Subject: Response To Request For Additional Information – Radiological Consequence
Analysis For Control Room Operators (TAC No. MA 3465)

Oyster Creek Generating Station (Oyster Creek)
Facility Operating License No. DPR-16
NRC Docket No. 50-219

**Response to Request for Additional Information - Radiological
Consequences Analysis for Control Room Operators**

Figure 1 Site Plot Plan showing principal release points

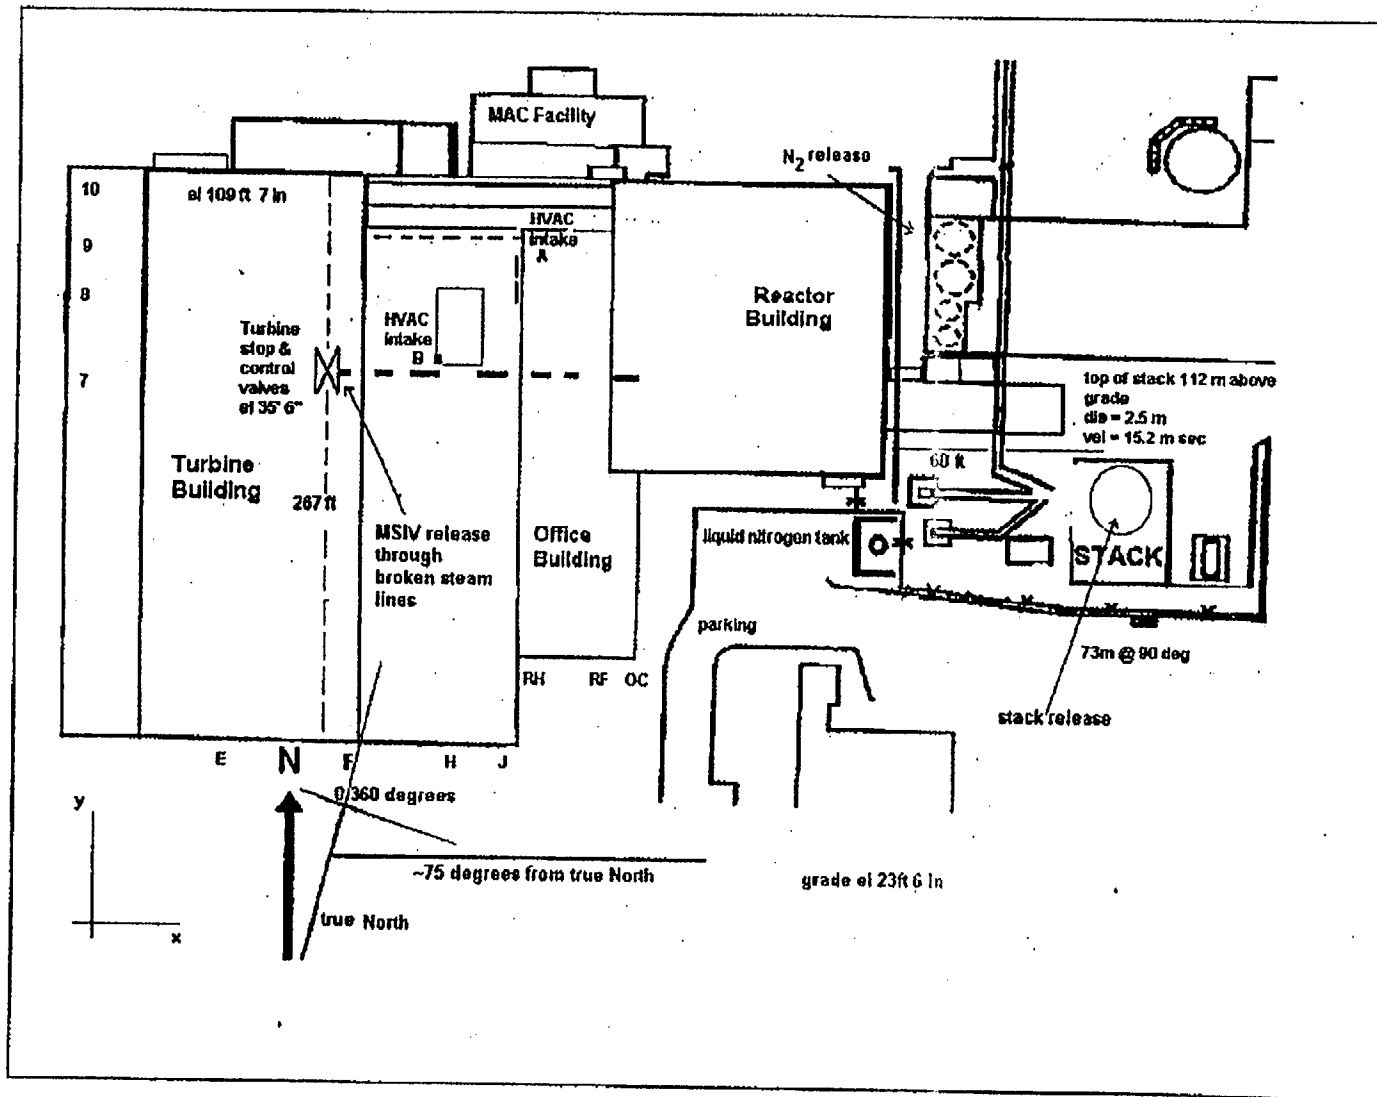
Where is the yard release location cited in the January 12, 2001, submittal and what methodology, inputs, and assumptions were used to calculate the control room intake relative concentration (X/Q) values? Why does selection of the assumed location and associated inputs and assumptions ensure that the resultant X/Q values are adequately conservative? Provide or reference plant drawings in the Safety Analysis Report or elsewhere that show the relationship between potential release locations from plant systems to the environment and from the environment to the control room intake with respect to distances, structural dimensions, and directions from true north.

The yard release is from a postulated rupture of the N₂ supply system, which provides purge for the drywell and torus. This release is not included in the current licensing basis for Oyster Creek but has been assumed in this analysis for additional conservatism. This line penetrates the reactor building on the Northeast corner of the reactor building. The distance from the N₂ line penetration at the reactor building Northeast corner to the "A" HVAC control room air intake is 45.1m. The "A" HVAC control room air intake is the closest of the two intakes to the N₂ line yard release point. For conservatism, the calculated X/Q for the N₂ line yard release to the "A" intake is also applied to the "B" intake. The release point for either of the two N₂ system reactor building bypass pathways located on the east side of the reactor building is assumed to lie in a direction 75 degrees from the control room air intake. The exact location of the potential release cannot be determined since the N₂ line runs along the wall of the reactor building. However, the short distance from any potential release point is in a direction normal to the east wall that runs 345 to 165 degrees, or approximately North-South. The normal to the east wall would, therefore, be at 255 degrees. The attached Figure 1, excerpted from supporting Calculation No. C-1302-826-E540-017, shows the relationship between the N₂ line yard release location to the environment and from the environment to the control room intake with respect to distances, structural dimensions, and directions from true north. This calculation is provided in AmerGen letter to the NRC dated September 24, 2001 (2130-01-20177).

As stated above, the exact location of the potential release cannot be determined since the N₂ line runs along the wall of the RB. However, the shortest distance from any potential release point is in a direction normal to the east wall that runs 345 to 165 degrees, or approximately North-South. The normal to the east wall would, therefore, be at 255 degrees. Therefore, adequate conservatism exists.
